Access Compliance Report Public Rights-of-Way (Curb Ramps)

Main Street: ROMELLE_AVE Cross Street: YORBA_ST Location: NW

ADA ID: RPRK220126121601 Ramp Type: Type 1 - Perpendicular Diagonal Initial Pass/Fail: Fail Overall Compliance: No Severity Score: 16

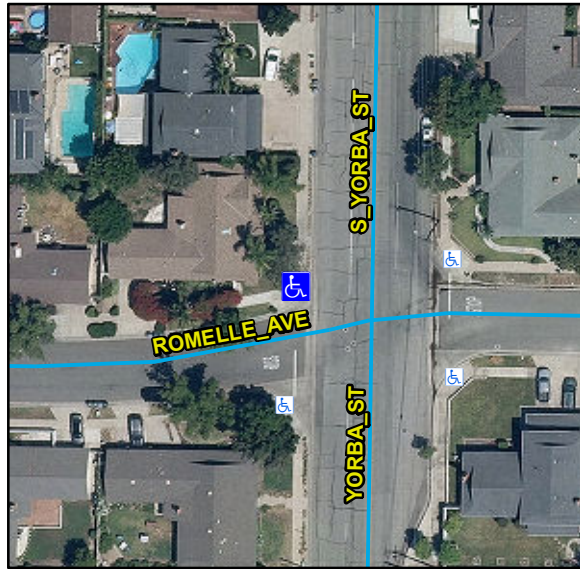
R304.2.2, STD 1115

Compliance	Description	Data	Compliance	Description	Data
N/A	Ramp Length (in)	83	N/A	Flare Type LT	
Yes	Ramp Width (in)	54			N/A
No	Ramp Run Slope (%)	10	N/A	Flare Slope LT (%)	N/A
Yes	Ramp Cross Slope (%)	2	N/A	Flare Traversable LT	N/A
N/A	Landing Present	N/A	N/A	Flare Type RT	
N/A	Landing Length (in)	N/A			N/A
N/A	Landing Width (in)	N/A	N/A	Flare Slope RT (%)	N/A
N/A	Landing Run Slope (%)	N/A	N/A	Flare Traversable RT	N/A
N/A	Landing Cross Slope (%)	N/A	N/A	DWS Provided	N/A
N/A	Landing Movement Obstructed?	N/A	N/A	DWS Contrast	N/A
	Landing Movement Type	N/A	N/A	DWS Length (in)	N/A
N/A	Landing Shared	N/A	N/A	DWS Full Width	N/A
N/A	Clear Space	Yes	N/A	DWS Offset Left (in)	N/A
N/A	Clear Space To Crosswalk (in)	N/A	N/A	DWS Offset Right (in)	N/A
N/A	Marked Crosswalk 1	No	N/A	Marked Crosswalk 2	No
	Crossing 1 Direction	S		Crossing 2 Direction	E
	Marked Crosswalk 1 Width (in)	N/A		Marked Crosswalk 2 Width (in)	N/A

Remove & Replace Curb Ramp With Two New Directional Ramps or Equivalent.
